Access Compliance Report Public Rights-of-Way (Curb Ramps)

Main Street: WEGEFORD_RD Cross Street: BUSHWOOD_CIR Location: S

ADA ID: RPRK211104135722 Ramp Type: Type 4 - Parallel Initial Pass/Fail: Fail Overall Compliance: No Severity Score: 30

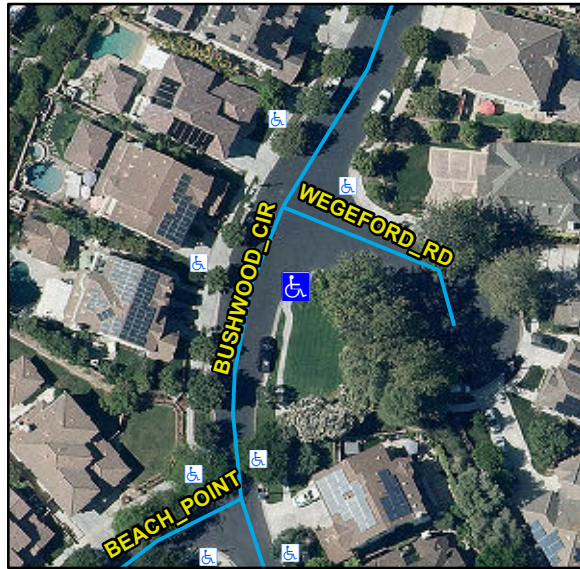
Compliance	Description	Data	Compliance	Description	Data
N/A	Ramp Length LT (in)	115	N/A	Ramp Length RT (in)	115
Yes	Ramp Width LT (in)	54	Yes	Ramp Width RT (in)	54
No	Ramp Run Slope LT (%)	13.3	Yes	Ramp Run Slope RT (%)	0.6
Yes	Ramp Cross Slope LT (%)	0.8	Yes	Ramp Cross Slope RT (%)	0.5
N/A	Landing Present	N/A	N/A	DWS Provided	N/A
N/A	Landing Length (in)	N/A	N/A	DWS Contrast	N/A
N/A	Landing Width (in)	N/A	N/A	DWS Length (in)	N/A
N/A	Landing Run Slope (%)	N/A	N/A	DWS Full Width	N/A
N/A	Landing Cross Slope (%)	N/A		DWS Offset Type	N/A
N/A	Landing Movement Obstructed?	N/A	N/A	DWS Offset Left (in)	N/A
	Landing Movement Type	N/A	N/A	DWS Offset Right (in)	N/A
N/A	Landing Shared	N/A			
N/A	Clear Space	Yes			
N/A	Clear Space To Crosswalk (in)	N/A			
N/A	Marked Crosswalk 1	No	N/A	Marked Crosswalk 2	No
	Crossing 1 Direction	NE		Crossing 2 Direction	NW
	Marked Crosswalk 1 Width (in)	N/A		Marked Crosswalk 2 Width (in)	N/A

Remove & Replace Curb Ramp With Two New Directional Ramps or Equivalent.
